SUBJECT: ISSUANCE OF AMENDMENT NO. 35 TO FACILITY OPERATING LICENSE NO. NPF-41, AMENDMENT NO. 22 TO FACILITY OPERATING LICENSE NO. NPF-51, AND AMENDMENT NO. 11 TO FACILITY OPERATING LICENSE NO. NPF-74, FOR THE PALO VERDE NUCLEAR GENERATING STATION, UNITS 1, 2, AND 3, RESPECTIVELY (TAC NOS. 68172, 68173 AND 68174)

The Amendments revise Technical Specification Table 3.6-1 to reduce the maximum actuation time of the containment isolation valves which isolate the containment air radioactivity monitor from 12 seconds to 1 second.

SAFETY EVALUATION BY THE OFFICE OF NUCLEAR REACTOR REGULATION  
RELATED TO AMENDMENT NO. 35 TO FACILITY OPERATING LICENSE NO. NPF-41,  
AMENDMENT NO. 22 TO FACILITY OPERATING LICENSE NO. NPF-51  
AND AMENDMENT NO. 11 TO FACILITY OPERATING LICENSE NO. NPF-74  
ARIZONA PUBLIC SERVICE COMPANY, ET AL.  
PALO VERDE NUCLEAR GENERATING STATION, UNIT NOS. 1, 2 AND 3  
DOCKET NOS. STN 50-528, STN 50-529 AND STN 50-530

FIGURE 1-1

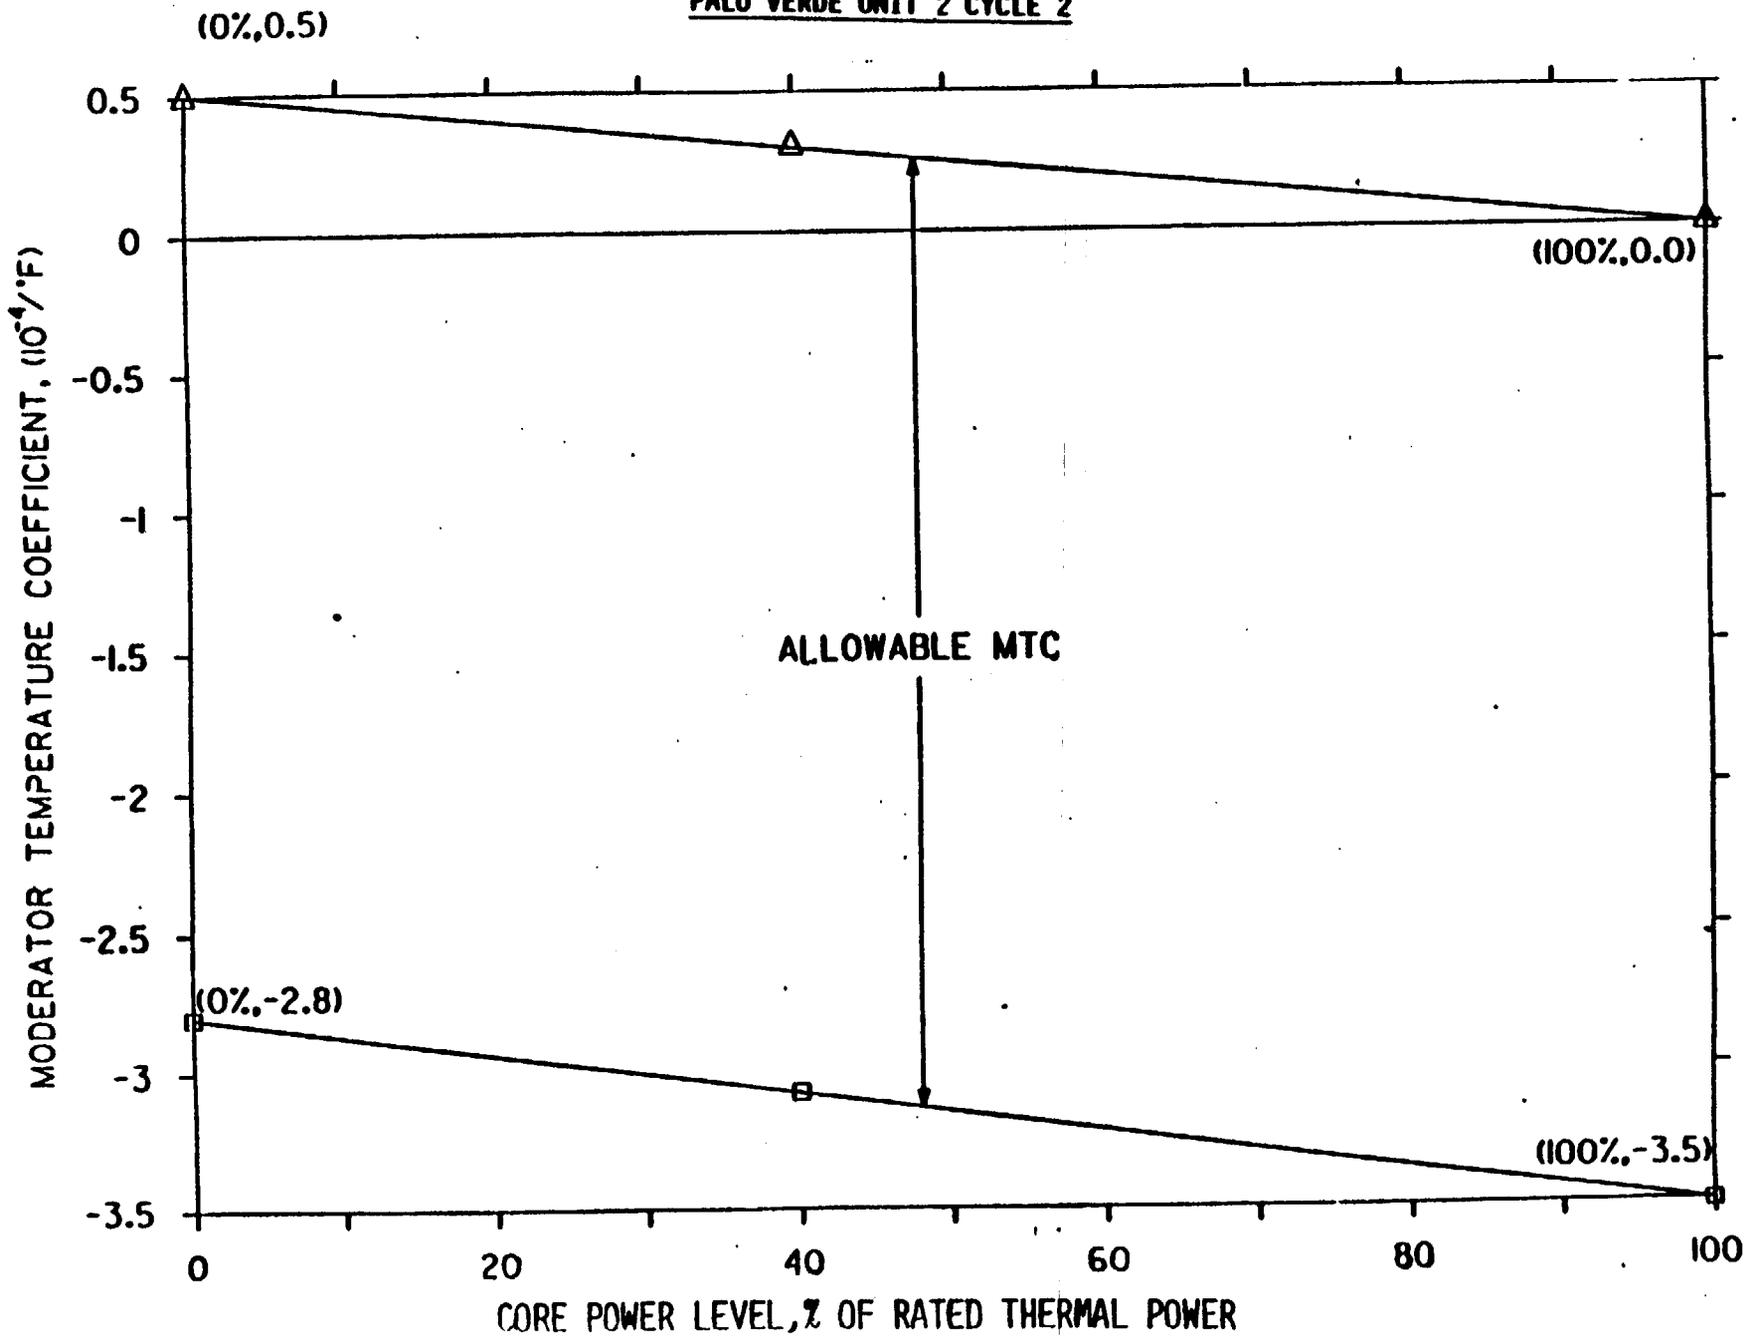
Also enclosed is a corrected Page 3/4 1-5 for the Palo Verde Unit 2 Technical Specifications. It was incorrectly captioned when it was revised in Amendment No. 19, dated May 5, 1988.
